## Urgent Field Safety Notice

10819177, Rev. A

**ADVIA Centaur®**  
**ADVIA Centaur® XP**

### Improper Manual Loading of Sample Racks

**Figure 1. Sample Entry and Inprocess Queues**

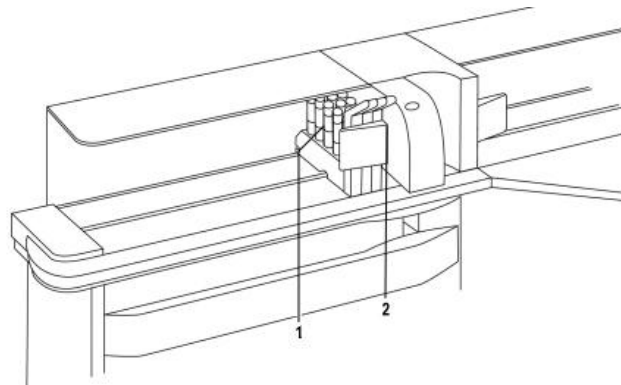
Pushing the sample racks may cause misreads of Sample IDs (SID) if the sample rack loading instructions are not followed exactly as described in the ADVIA Centaur or ADVIA Centaur XP Operator's Guide. Refer to Figure 1 in the Actions to be Taken by the Customer section.

If a sample rack is manually pushed with a slight forward nudge to the entry position without placing it on the rack positioning guide, the barcoded tube SID can be assigned to different positions in the rack. This may lead to misreported results.

When loading a sample rack, ensure the sample rack notch rests on the raised area of the sample entry queue (1) and the system automatically moves the rack to the loading position. This raised guide ensures the sample rack is positioned correctly and will accurately scan each barcode as it enters the inprocess queue (2). **Do not** push the sample racks into the system.
